RECORD OF DECISION

Operable Unit One
New Cassel/Hicksville Ground Water Contamination Superfund Site
Towns of North Hempstead, Hempstead and Oyster Bay,
Nassau County New York

United States Environmental Protection Agency
Region 2
New York, New York
September 2013

DECLARATION FOR THE RECORD OF DECISION

FIGURE 2.2

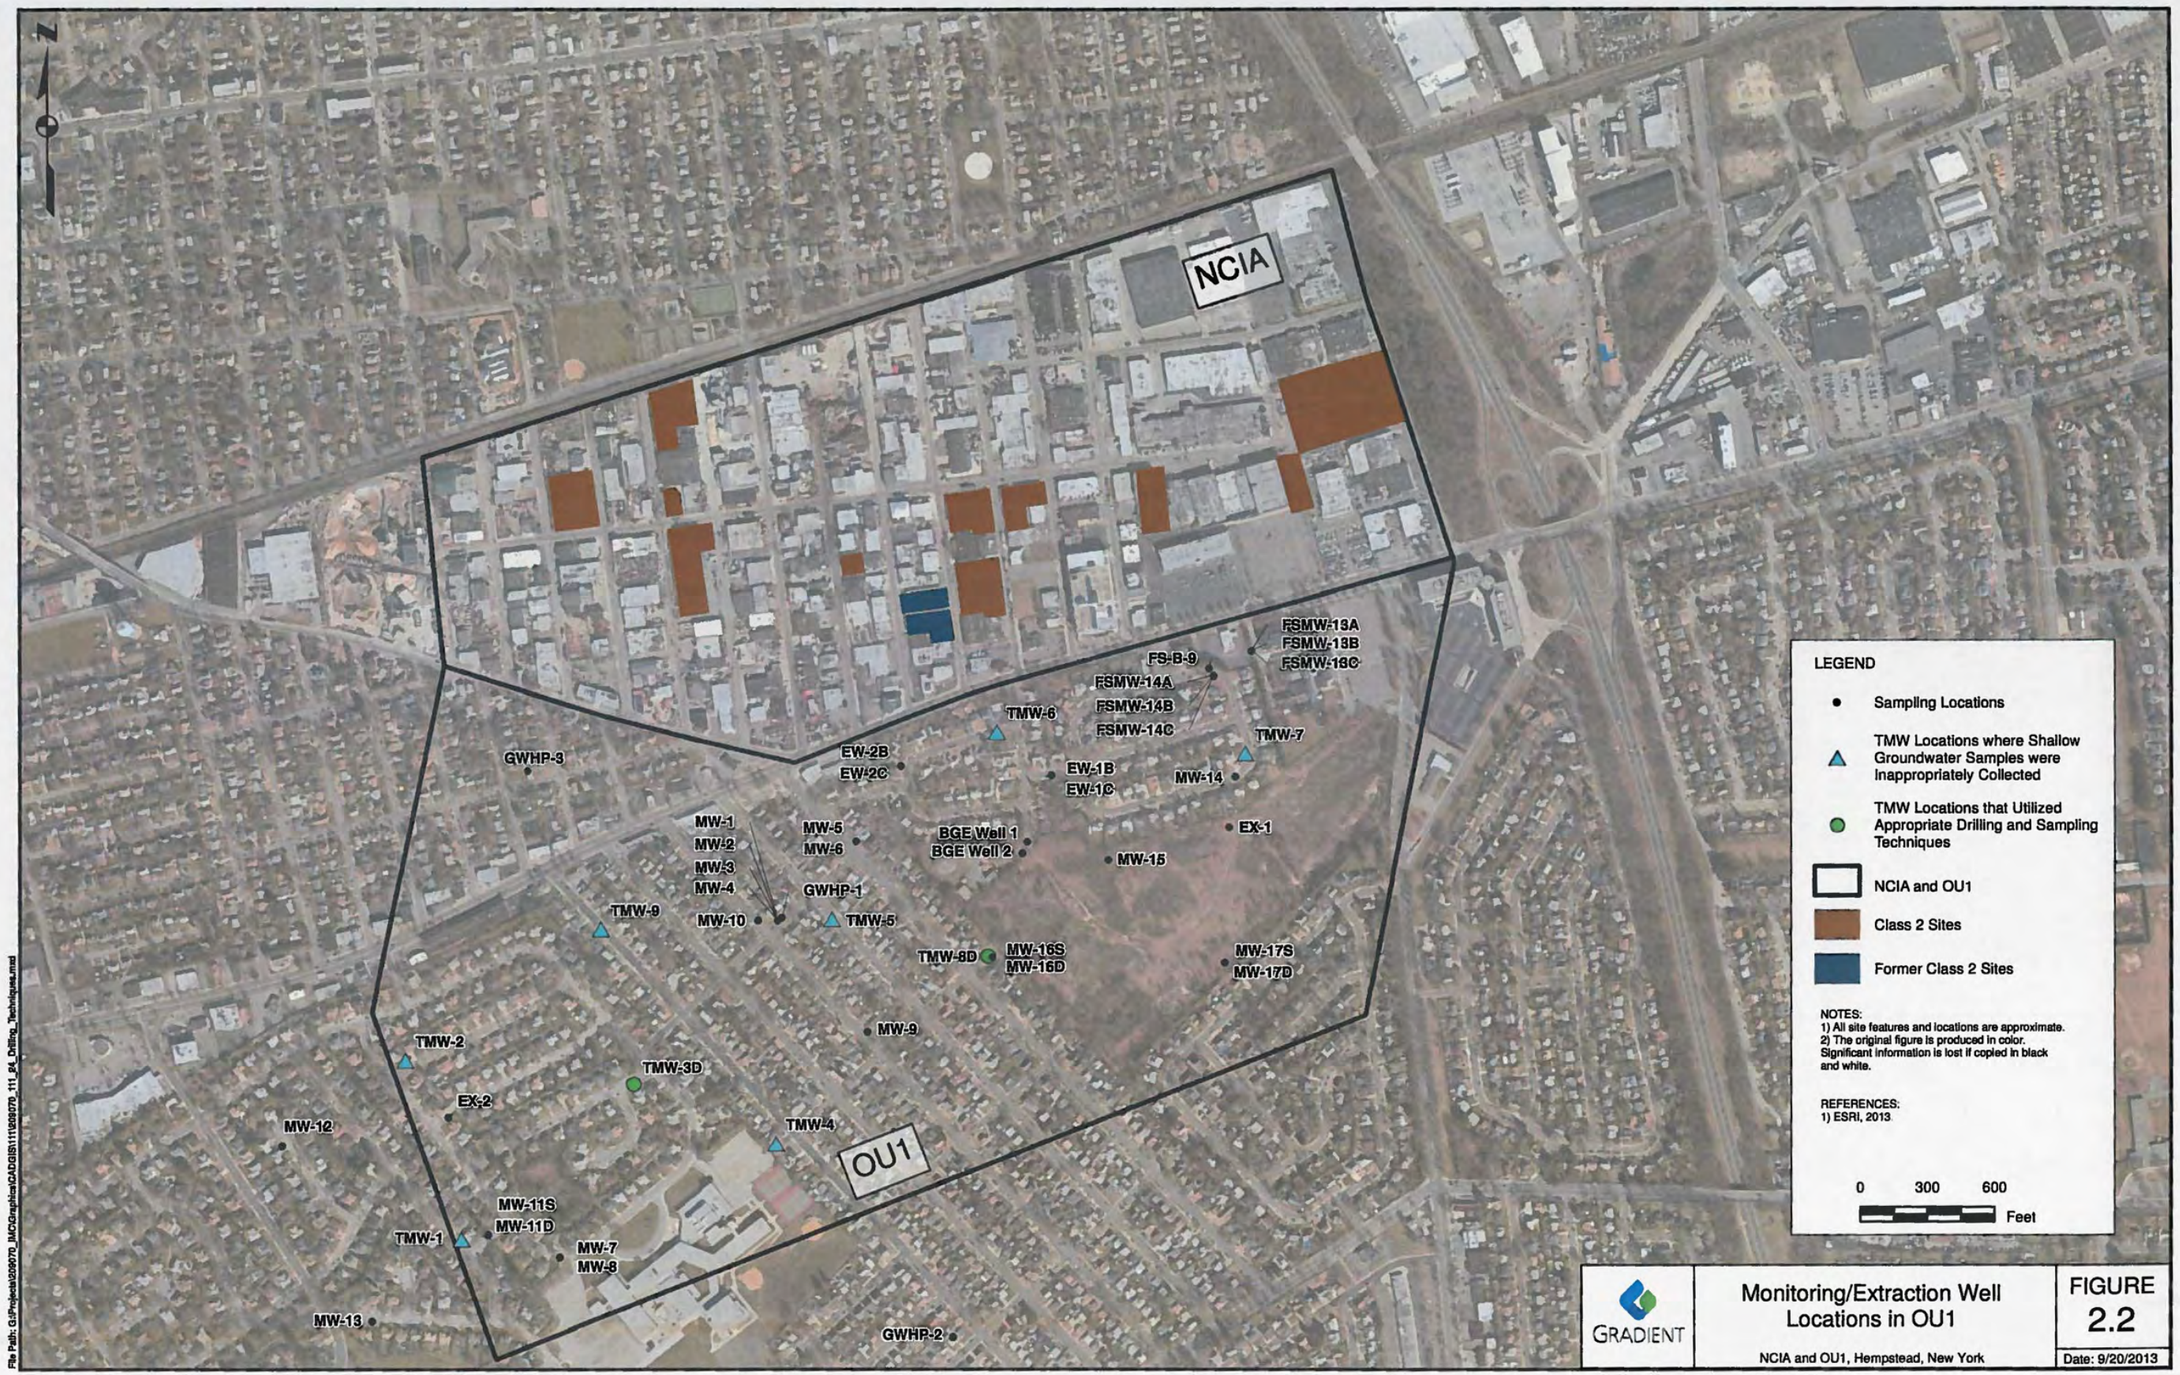
A significant portion of the OU1 data, relied on by USEPA, were collected using inappropriate methods. Nine TMWs were installed in 2008 as part of a PDI conducted by D&B (2009; Figure 2.2). Seven of the nine temporary wells were installed and sampled inappropriately, causing cross-contamination between the shallow and deep groundwater samples. Furthermore, groundwater quality data from the TMWs are not reproducible. USEPA did not exercise sufficient care in the use of this data in the development of their CSM.

FIGURE 2.5

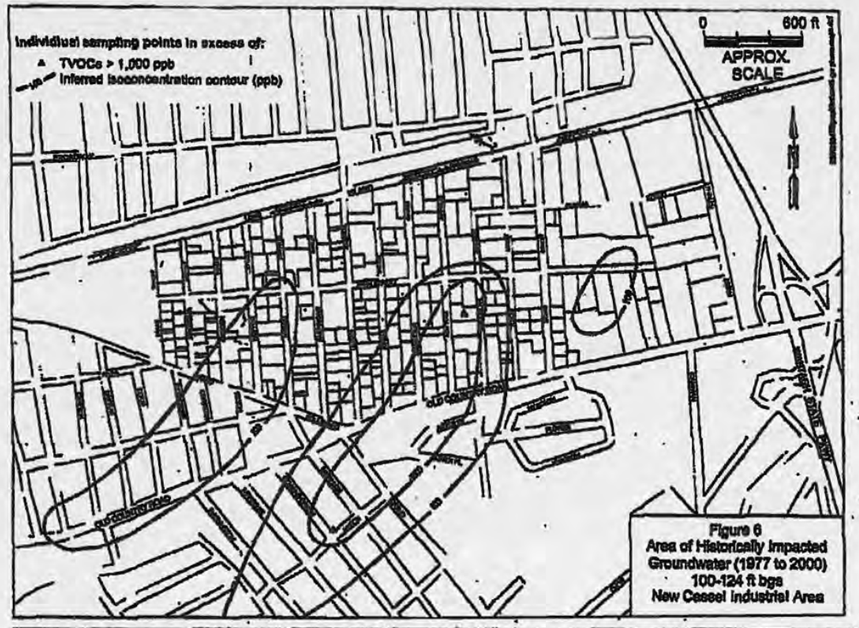
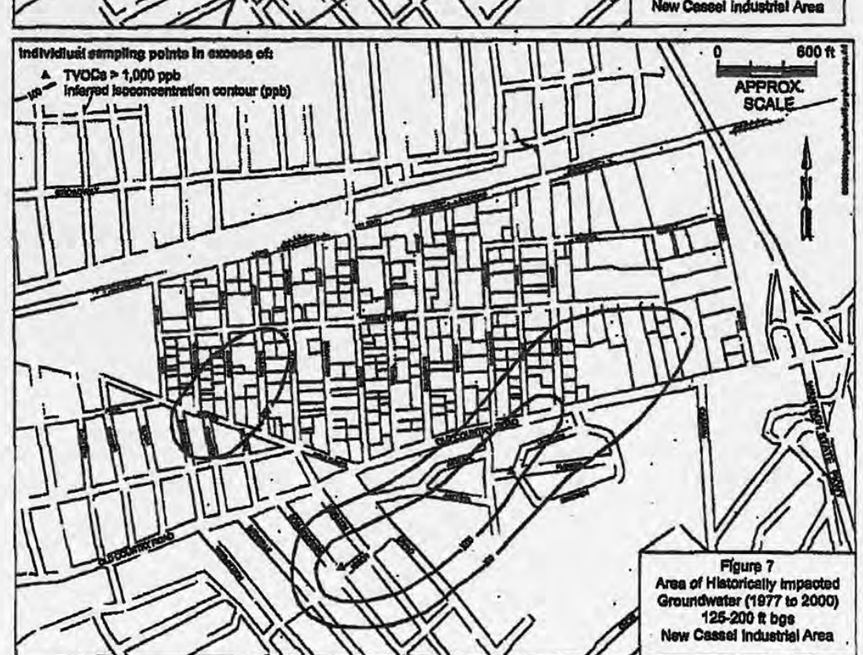
The direction of plume transport depicted in technical reports prepared by NYSDEC corroborate the southwesterly groundwater flow direction. In addition, plume maps presented in the 2003 ROD issued by NYSDEC (2003) [reproduced in Figure 2.5], indicate that NCIA-related plumes migrate to the southwest. The ROD (NYSDEC, 2003) states that "the axis of the plume is generally in the direction of the flow of shallow groundwater."

FIGURE 2.6b

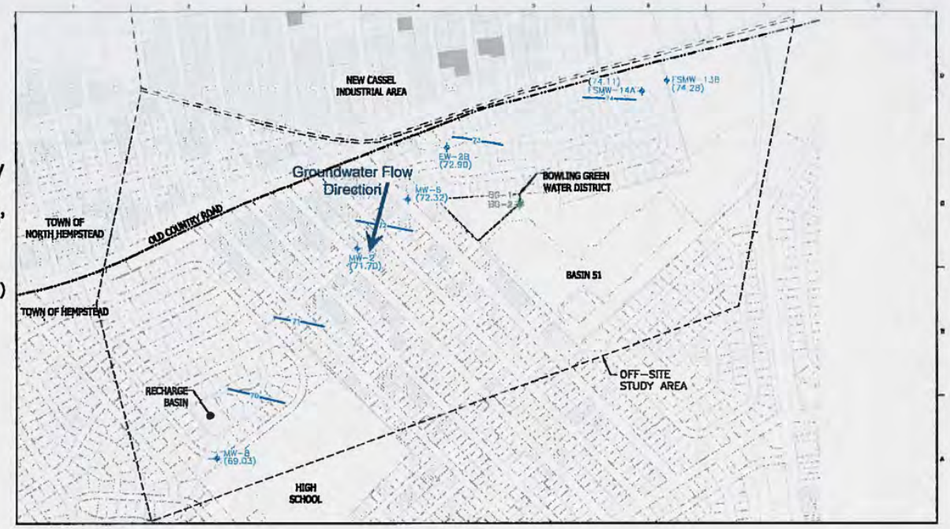
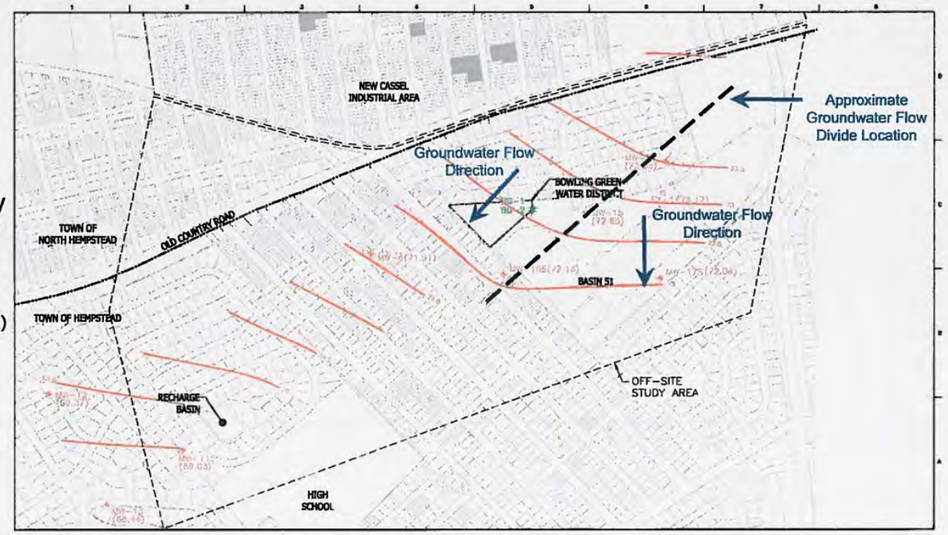
Recent groundwater elevation data confirm the southwesterly groundwater flow direction (Figures 2.6a and 2.6b). Groundwater elevations in the UGA, presented in the 2000 Remedial Investigation/Feasibility Study (RI/FS) (LMS, 2000) indicate that the shallow groundwater flows to the southwest (Figure 2.6a). In the 2011 PDI (HDR, 2011), HDR installed 11 additional monitoring wells in the OU1 Magothy and measured groundwater elevations in both new and existing wells (Figure 2.2). Several of the new wells (MW-11S/D, MW-16S/D, and MW-17S/D) were couplets where adjacent shallow and deep monitoring wells were installed. Thus, elevation data from these wells provide further corroboration of the flow directions within the Magothy Aquifer and also provide a more robust dataset for evaluating the vertical flow gradient within OU1. The results of the HDR monitoring confirm that shallow groundwater (130-140 ft-bgs) flows to the southwest (Figure 2.6b). Furthermore, at mid-aquifer depth (205 ft-bgs), the groundwater flow direction has a much stronger westerly flow component (Figure 2.6b).[3]

Corrected Molar Analysis Depiction

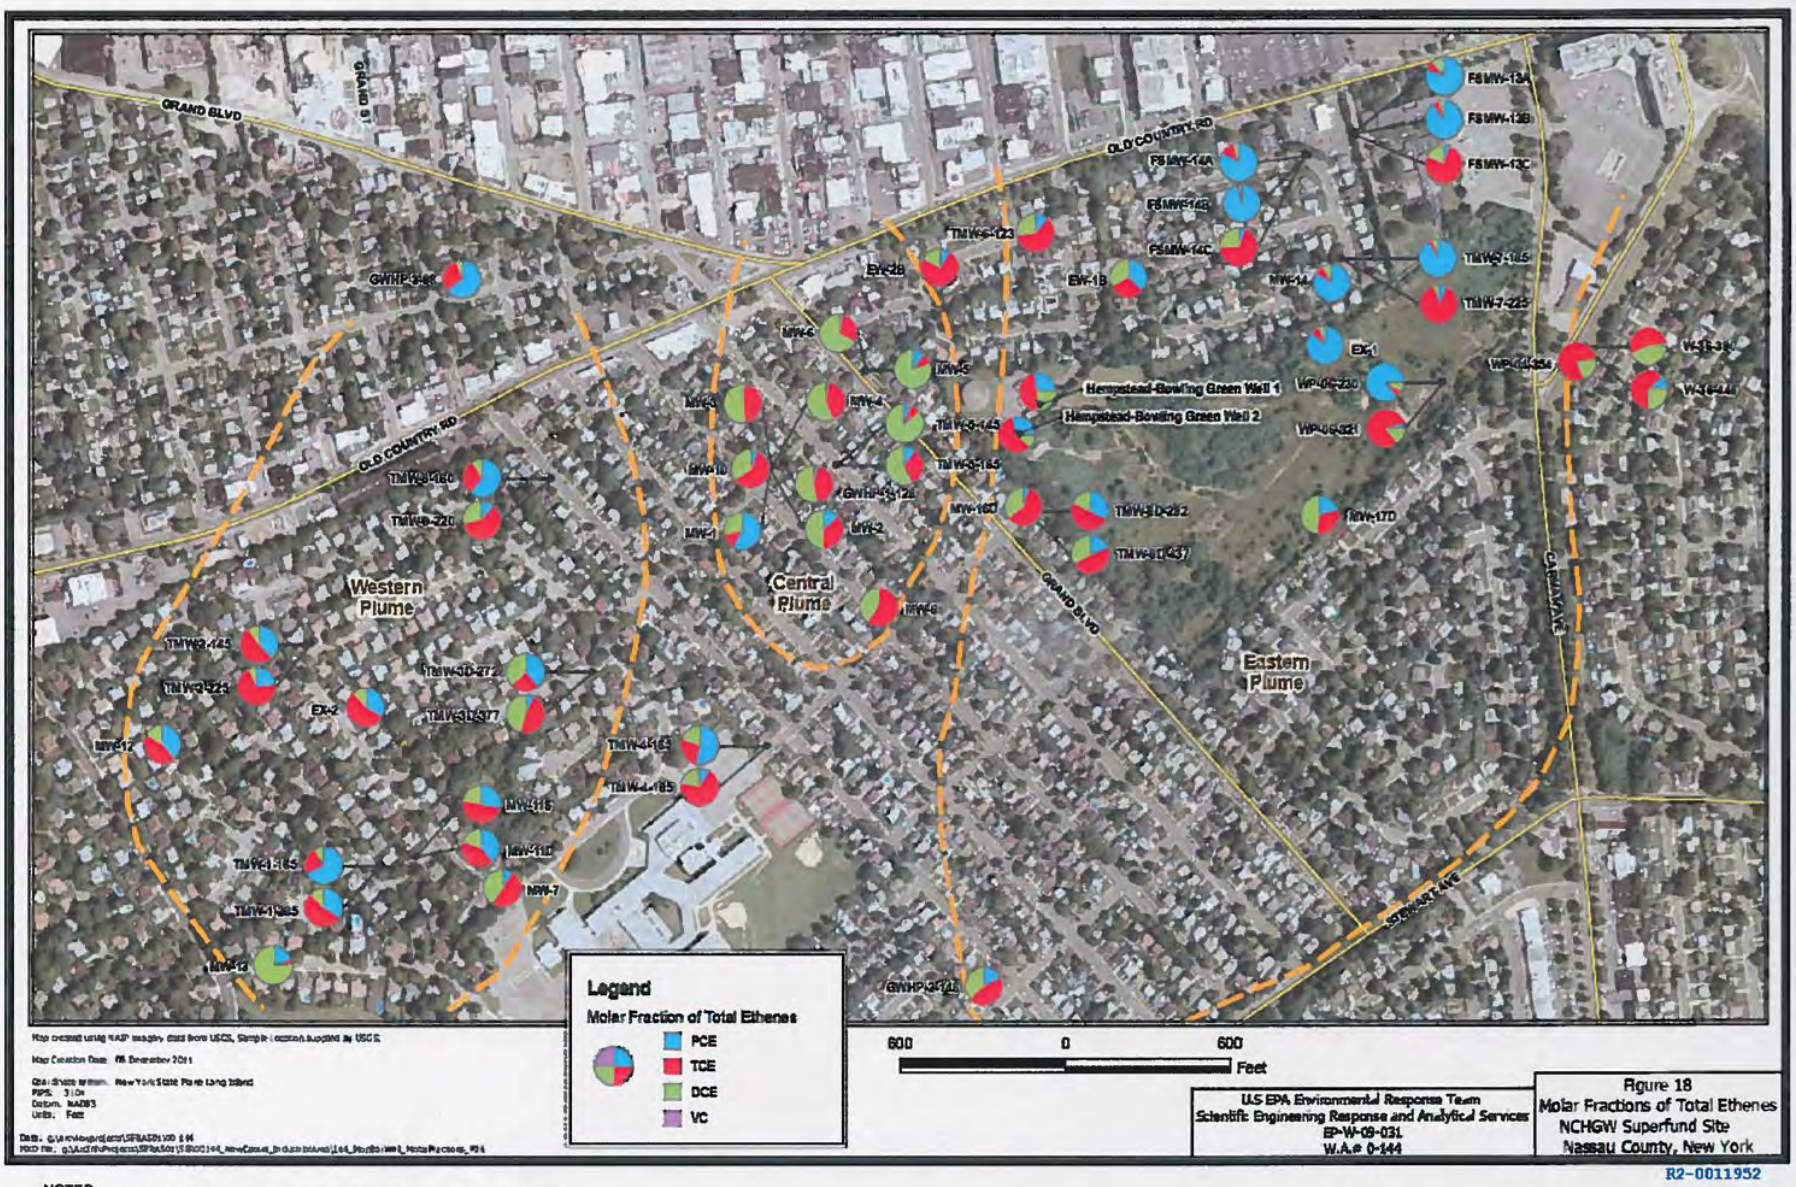
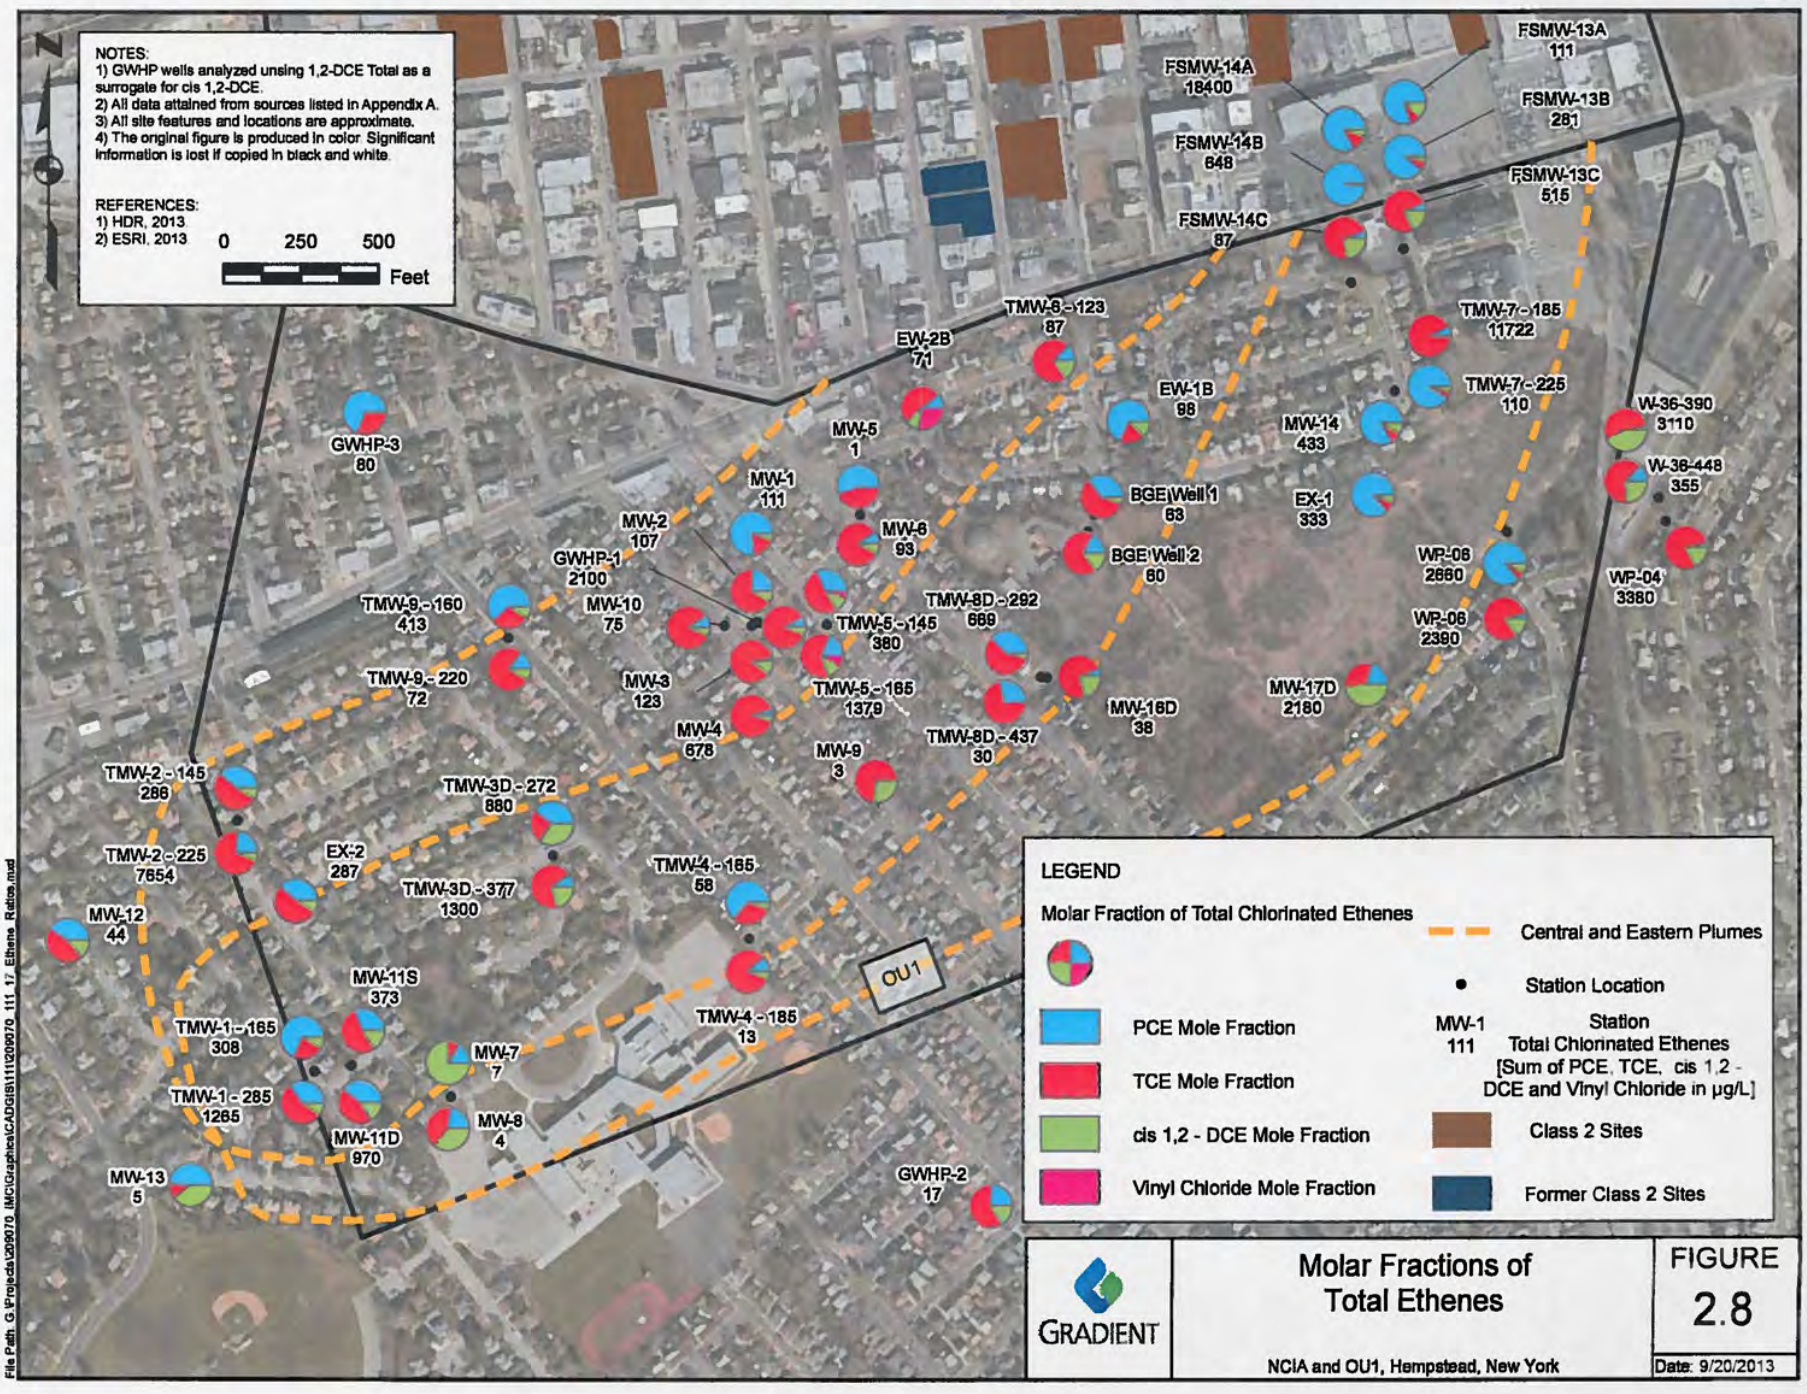
The molar ratio analysis presented in the Supplemental RI Technical Memorandum (Bolduc, 2013) and relied on by USEPA in its Proposed Plan is incorrect. The RI molar ratio analysis assumes that all dichloroethylene (DCE) isomers (cis-1,2-DCE, trans-1,2-DCE, and 1,1-DCE) are degradation products of the higher molecular weight chlorinated ethenes (PCE and TCE). While cis-1,2-DCE is the predominant dichloroethylene isomer formed during the degradation of PCE and TCE, the 1,1-DCE isomer is formed by the abiotic hydrolysis of TCA (Wiedemeier *et al*., 1999). Thus, the RI molar ratio analysis presented by USEPA mischaracterizes the breakdown pathways and does not allow for the differentiation between the degradation products in PCE/TCE and TCA plumes. Because TCA and its daughter products are indicators of the Central Plume, correctly depicting the chlorinated PCE/TCE and TCA degradation chains is essential for delineating the spatial extents of the OU1 plumes and for appropriately assigning plumes to source areas.

USEPA's incorrect molar ratio analysis leads to a mischaracterization of the spatial extents of the OU1 plumes and to incorrect attribution of plumes to source areas. We reevaluated the molar analysis using the correct degradation pathways. For the chlorinated ethenes, we have analyzed the molar fractions of PCE, TCE, cis-12-DCE, and vinyl chloride in OU1 monitoring wells (Figure 2.8). For the TCA degradation chain, we have analyzed the molar fractions of TCA, 1,1-DCE, and 1,1-DCA (Figure 2.9). Conclusions drawn from this corrected analysis, summarized below, differ significantly from those presented in the RI.
